## CITY OF PATASKALA PLANNING & ZONING COMMISSION

### STAFF REPORT

#### TCOD Application TCOD-21-002

### TCOD-21-002 Staff Review

**SITE PLAN**

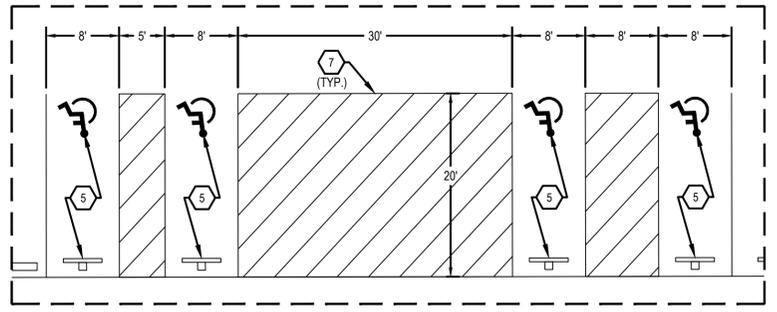
1. It is recommended the proposed western driveway radius be altered to the west as to not encroach the projected property line.
2. Future engineering review will be conducted during required submission.

- i) **Setback identified at 75-feet, by using SWLCWSD revise to 50'. Provide actual distance from R/W line to closest point of structure, as well as to closest point of parking lot.**

- i) **Plans refer to Sheet C7.1, which is not included.**

- 1) 1291.07(B): Number shall be in compliance with ADA guidelines. Accessible spaces shall be a minimum of 11-feet wide and 19-feet deep, with a 5-foot wide access aisle on one side.
  - a) ADA spaces only 8'x20', width needs revised to 11'.
- ~~2) 1291.07(B)(1-3): Proper signage shall be posted.~~
  - ~~a) Note included on plans.~~

a) **Parking aisles will need arrows indicating flow of traffic.**

- b. Stormwater design to be provided for final engineering review.
  - c. The ultimate ROW width for Broad St. is planned for 120' (60' from CL), please show accordingly.
